**Project Name: UNIVERSITY OF CALIFORNIA, MERCED  
SCIENCE AND ENGINEERING BUILDING 2**  
**Project No.: 900020**

**ADDENDUM NO. 4**  
to the **CONTRACT**  
**DOCUMENTS December 12,**  
**2011**

PROJECT NAME  
 38354.000 900020  
 PROJECT NUMBER UC PROJECT NUMBER  
**SK-M44**  
 DRAWING NUMBER

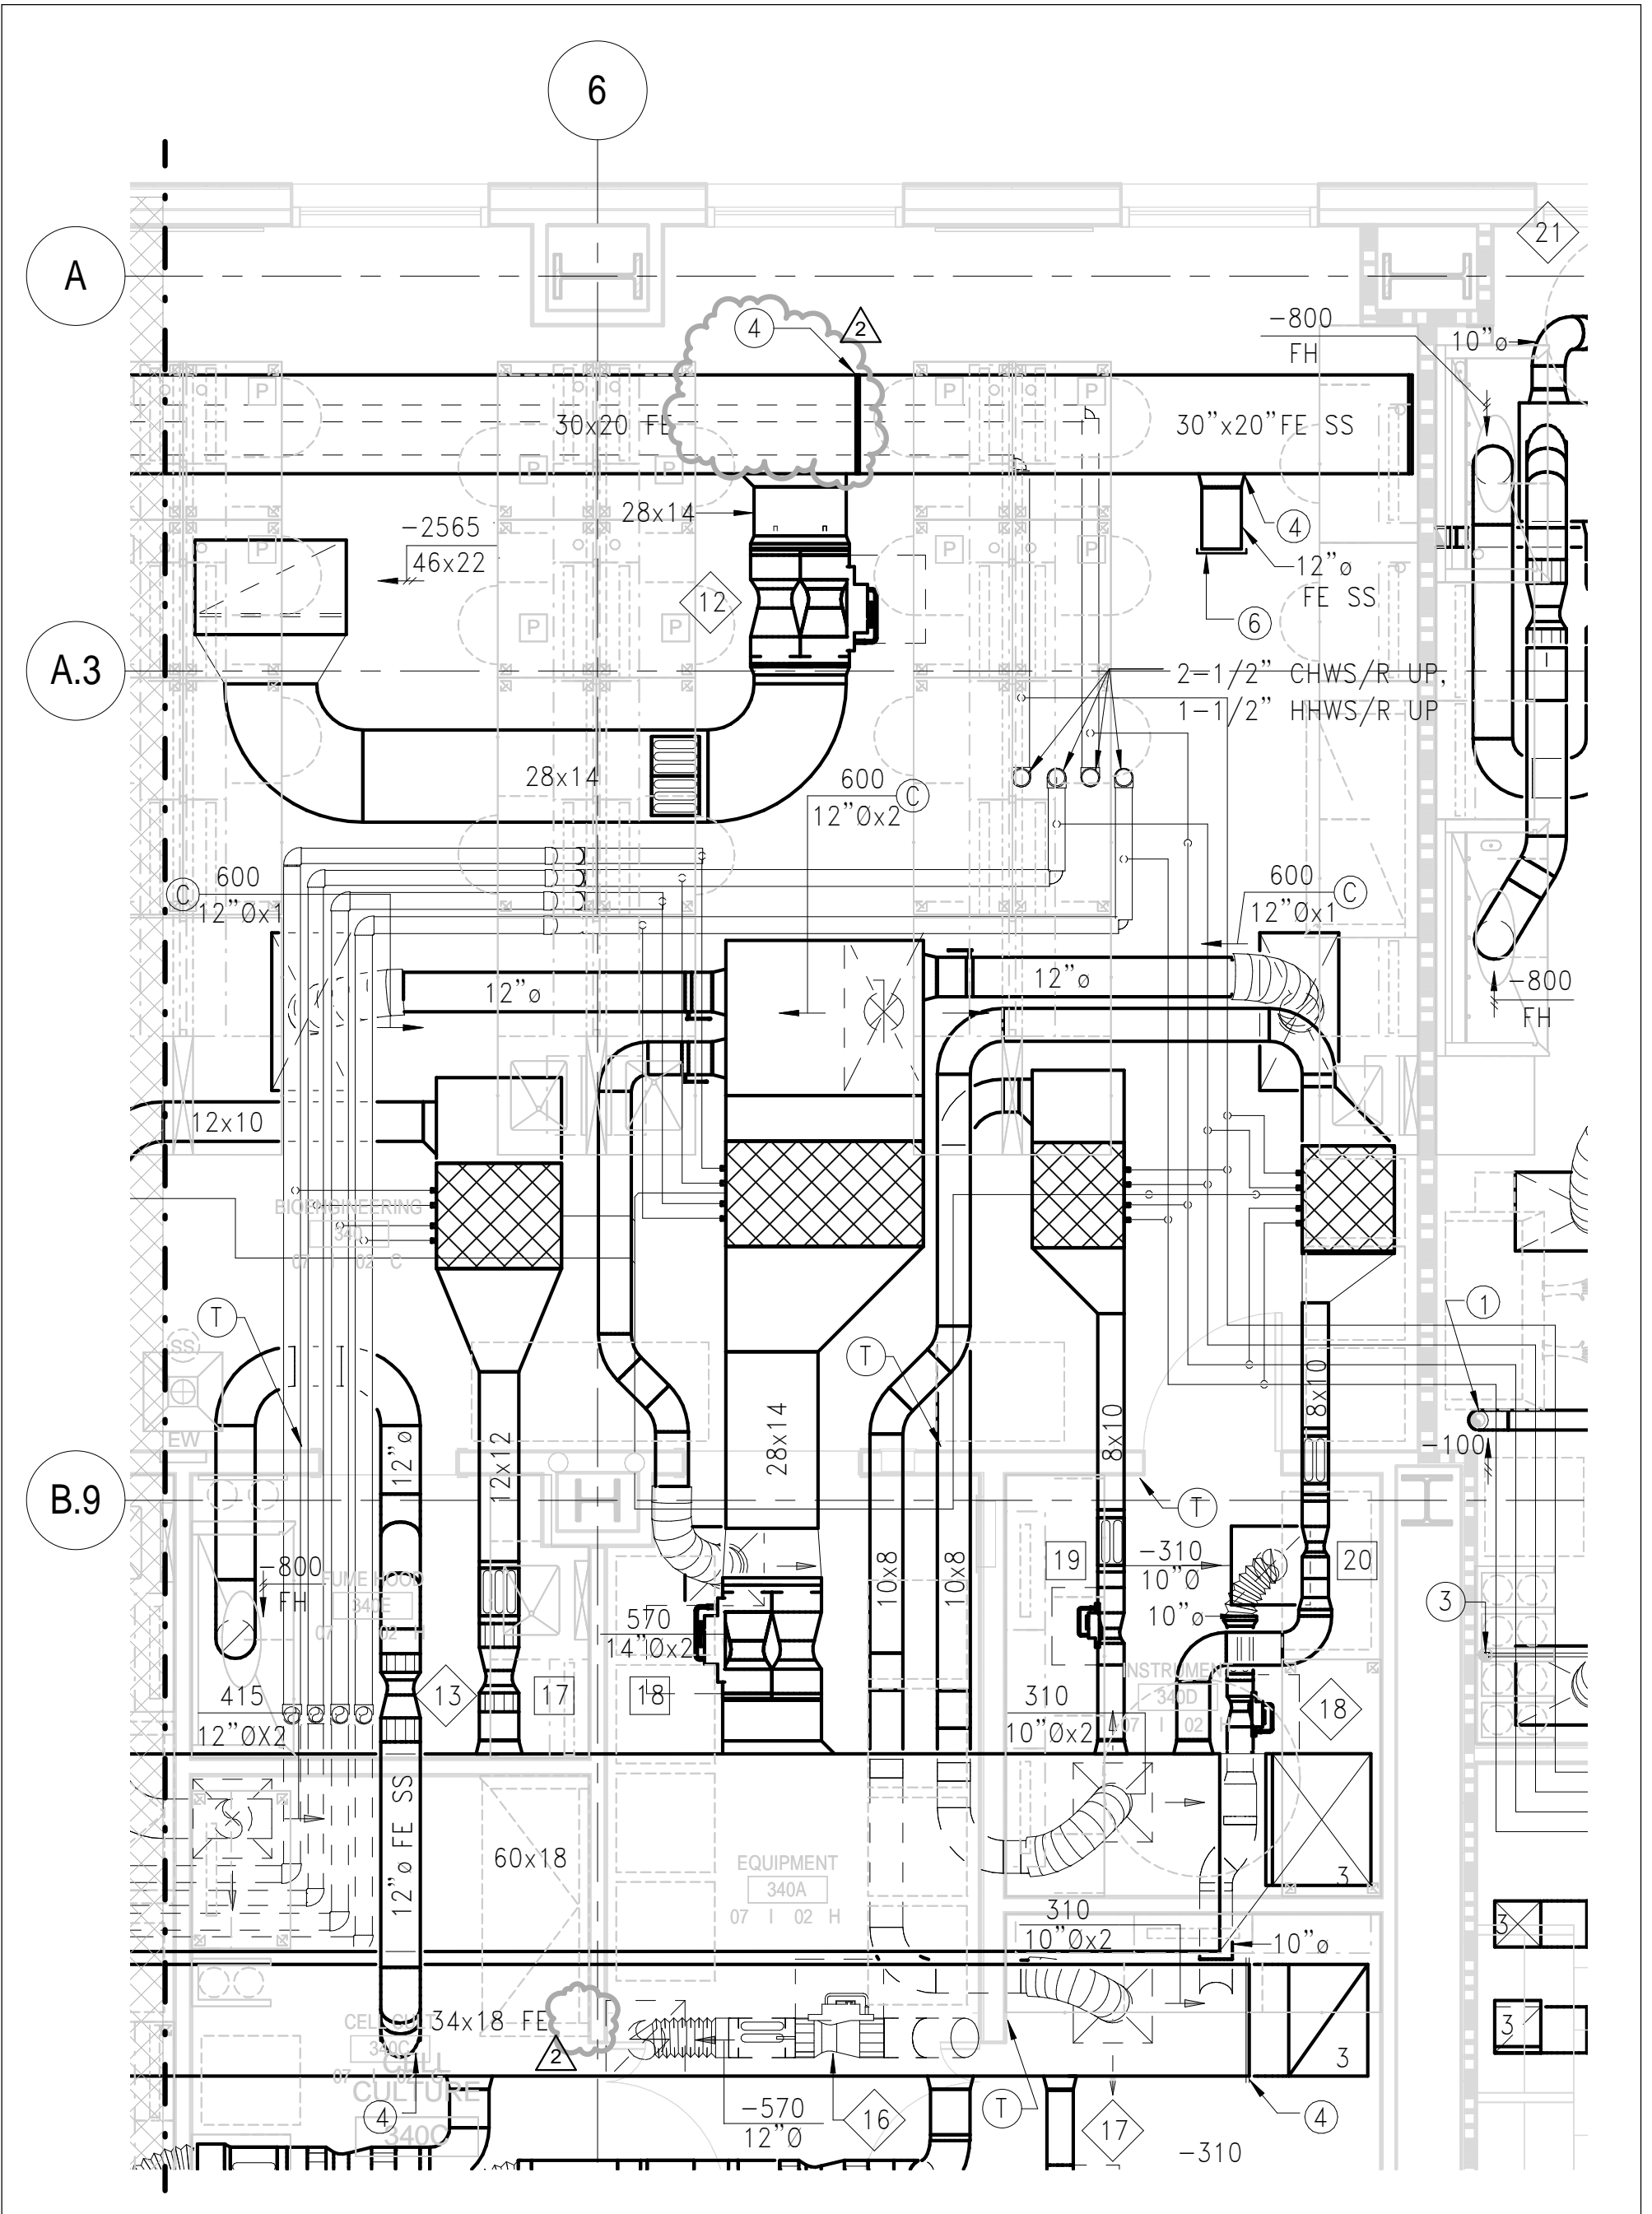
DRAWING TITLE  
 M2.3A  
 DRAWING REFERENCE  
 1/4" = 1'-0"  
 DRAWING SCALE  
 12/12/11  
 DATE

DRAWING TITLE	P3.6 & D-ALT10-P3.6
DRAWING REFERENCE	NONE
DRAWING SCALE	12 DEC 2011
DATE	UC Merced Science and Engineering Building 2
PROJECT NAME	38354.000
PROJECT NUMBER	SK-P12
DRAWING NUMBER

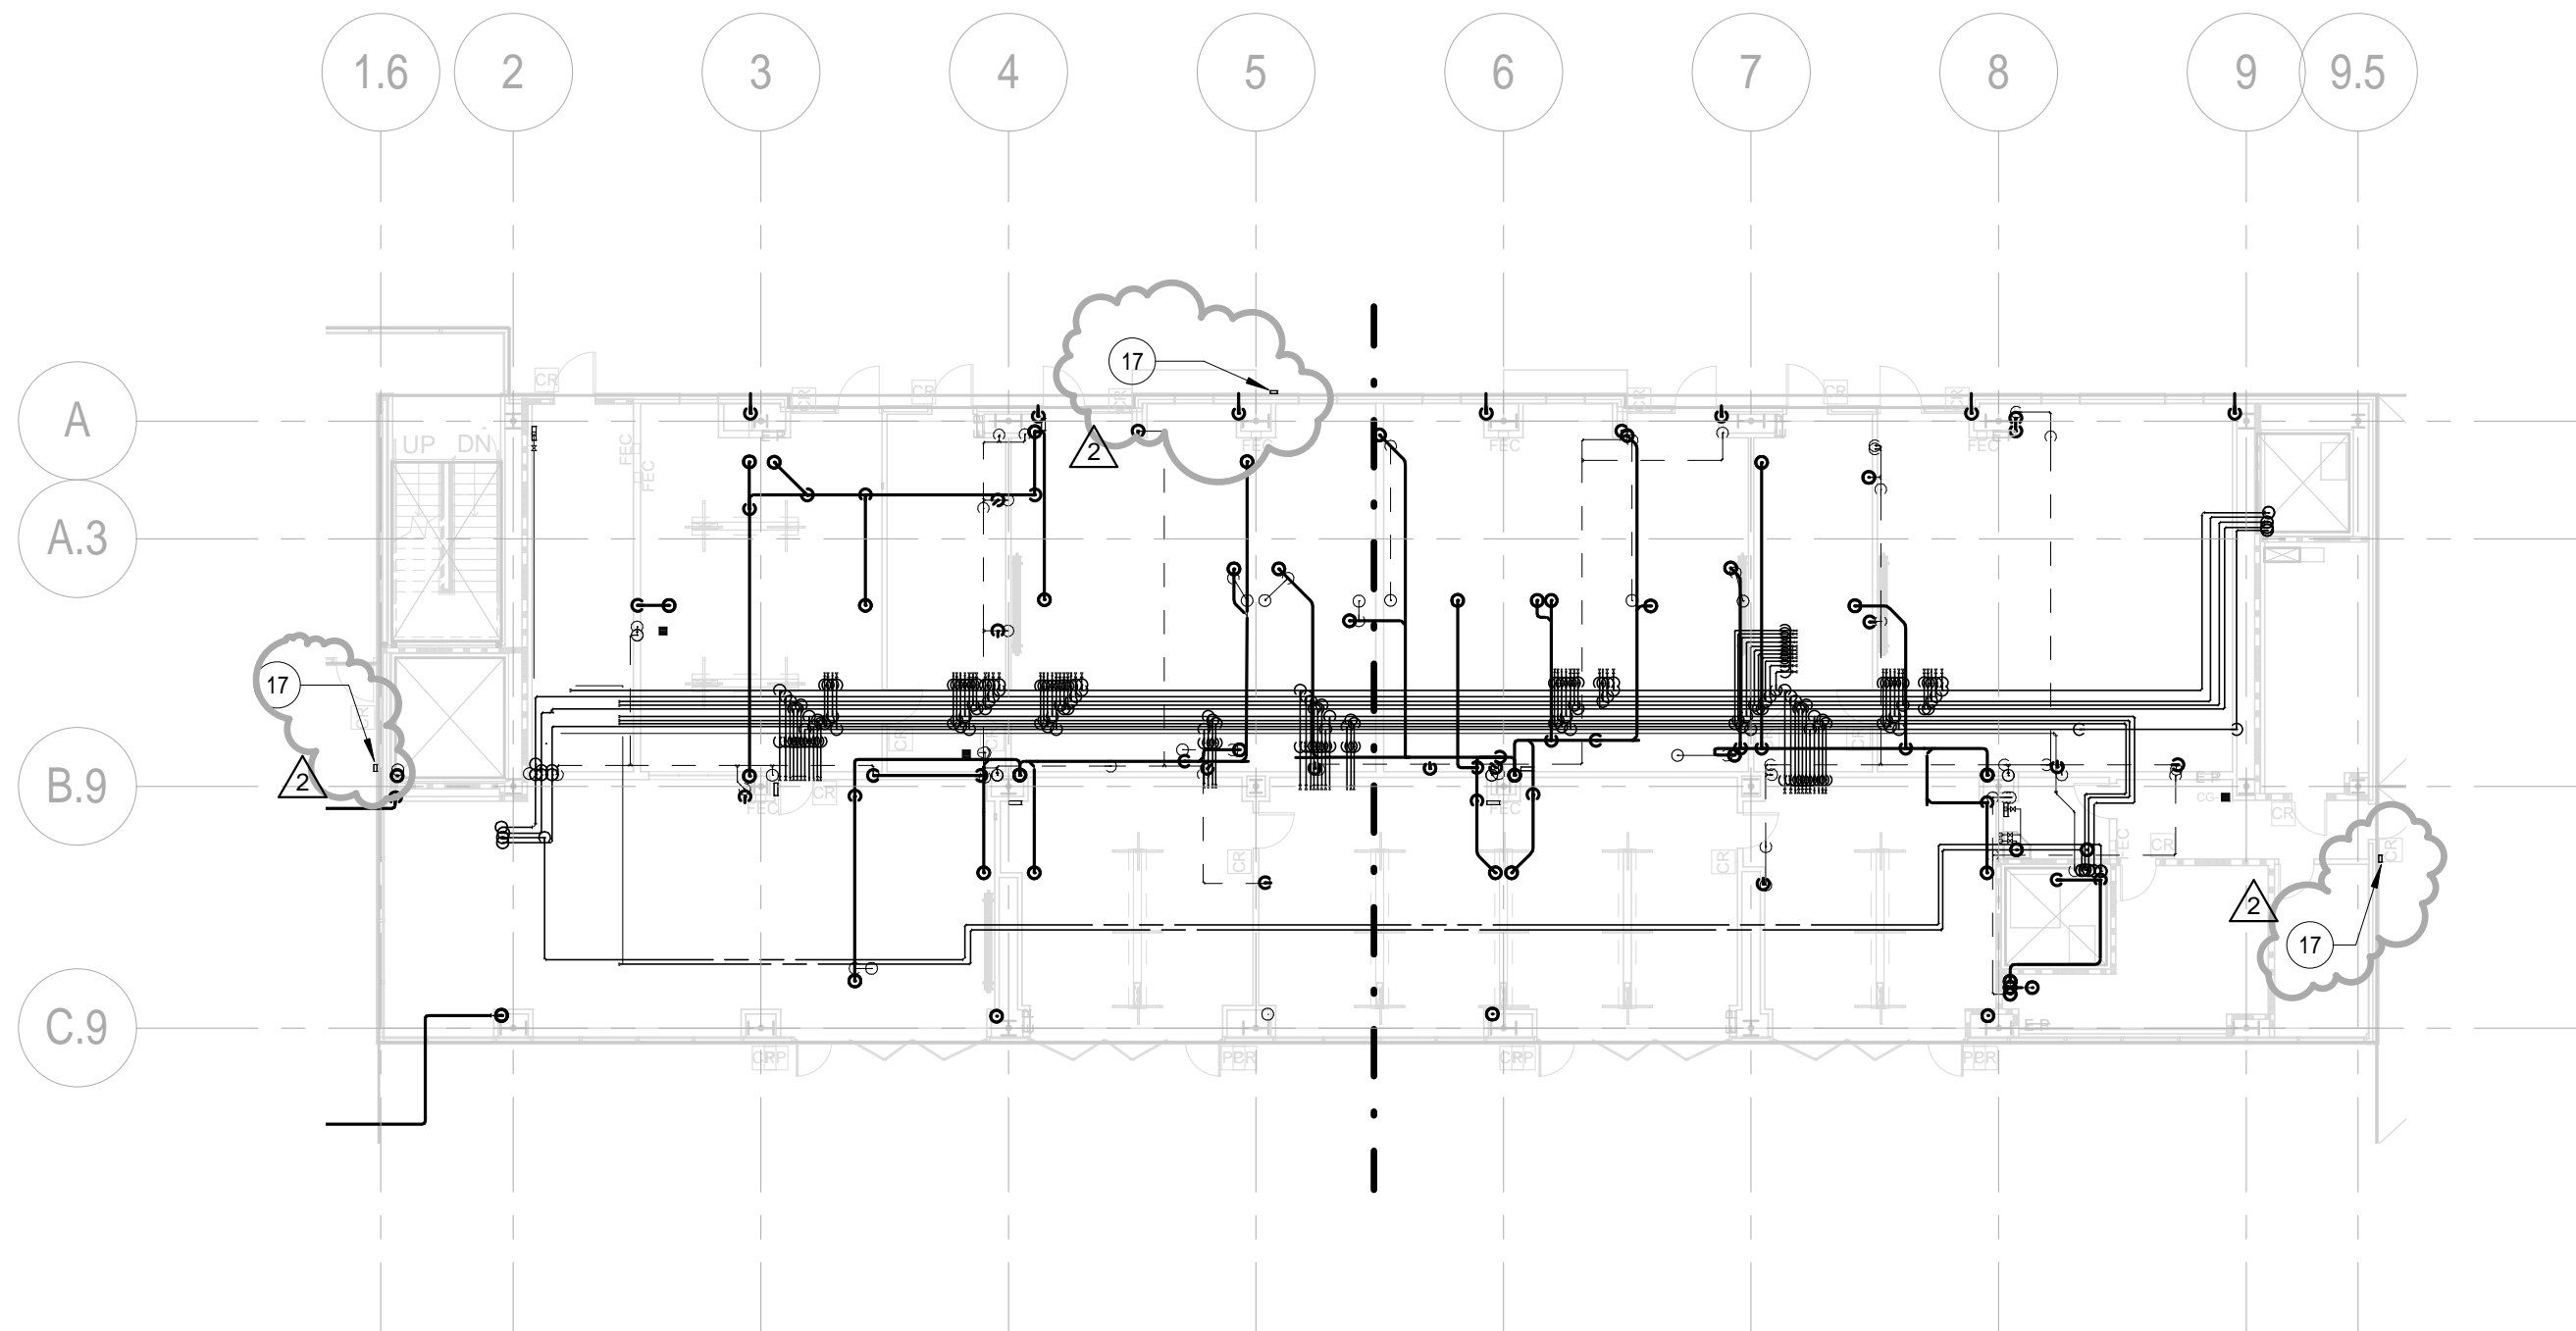
17 HB-3. PROVIDE 3/4" DCW, CONNECT TO FLOOR DCW MAIN. COORDINATE EXTERIOR ELEVATION WITH ARCHITECTURAL.
